Wiltshire Council Planning Consultation Response

URBAN DESIGN

Application No: PL/2025/09486

Site Address: Land South of Trowbridge

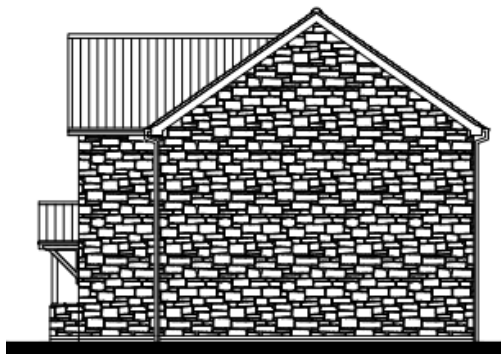
In contrast, the RM Application proposes predominantly traditional house types, which does not align with the DAS vision or the intended character for this site. This inconsistency extends to ancillary elements such as bin and cycle stores.

Recommendation: To deliver the high-quality, locally distinctive design envisaged in the DAS and to create a positive southern edge to Trowbridge, the RM Application should adopt a more contemporary architectural approach. This could include modern detailing, varied rooflines, and materials that reflect current design principles while respecting local context, in accordance with CP57 and the WDG.

✓ Reason - The matter has been partially resolved. Whilst the proposals depart from the contemporary approach established in the approved plans, the consistent use of materials to articulate character areas, together with symmetrical street scenes and well-defined gable and gabled features, provides a coherent and legible approach to composition and placemaking. The additional use of bay windows to plots 2-7 will further enhance the streetscene.

Plot 19 Coppice (WC window only)

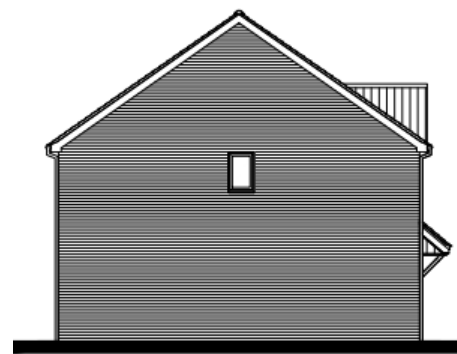
13. Street/street corner return elevations and street/open space corner return elevations have largely attractively placed and proportioned windows utilising house types that are consciously designed for this purpose, but there are the following exceptions below in locations - some marked as ‘Key corner turning buildings’ on the DPP. These would represent ‘what red looks like’ BfHL (pp 54-55) rather than the preferred ‘what green looks like’ (pp 52-53), and WDG expectation 4.2.8. ‘Where buildings are on a corner both public elevations should be designed as ‘frontages’ and have windows from habitable rooms in them’.

✓ The matter has now been resolved
